UNITED STATES PATENT AND TRADEMARK OFFICE

Office Action Summary

This is the first Office action for the serial number 10/814,586, METHODS AND APPARATUSES FOR ASSEMBLING RAILINGS, filed on 4/1/04.

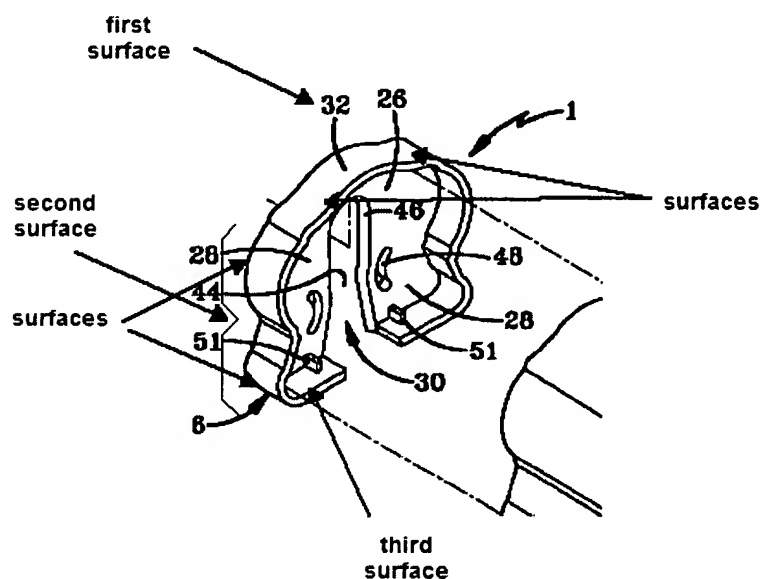
Claims 80-96, 99 and 104 are rejected under 35 U.S.C. 102(b) as being anticipated by US Patent # 5,788,224 to Platt.

Patt teaches a rail assembly comprising a rail (2), a post (3) and a bracket (1) for mounting the rail to the post. The bracket comprises a post surface (28) at least a portion of which is configured to abut a mounting surface of the post, at least two surfaces (32 and on the side adjacent to element 32) configured to be associated with and not parallel to the post surface of the bracket. A first surface (32) of the at least two surfaces is configured to accommodate the rail mounted to the post in a first configuration and a second surface (on the side adjacent to element 32) of the at least two surfaces is configured to accommodate the rail mounted to the post in a second configuration different from the first configuration. The first configuration of the rail is configured to be mounted to the post at a first angle relative to the mounting surface of the post and in the second configuration of the rail is configured to be mounted at a second angle relative to the mounting surface of the post different from the first angle. Both of the first

configuration and the second configuration of the rail is configured to be in a substantially horizontal orientation. The first surface comprises at least two first surfaces (two surfaces are inclined from the top of element 32). The second surface comprises at least two second surfaces. The assembly further comprises the third surface (located on the bottom of the bracket) configured to be associated with the post surface. See drawing of figure 2 from Platt's invention shown below for clarification:
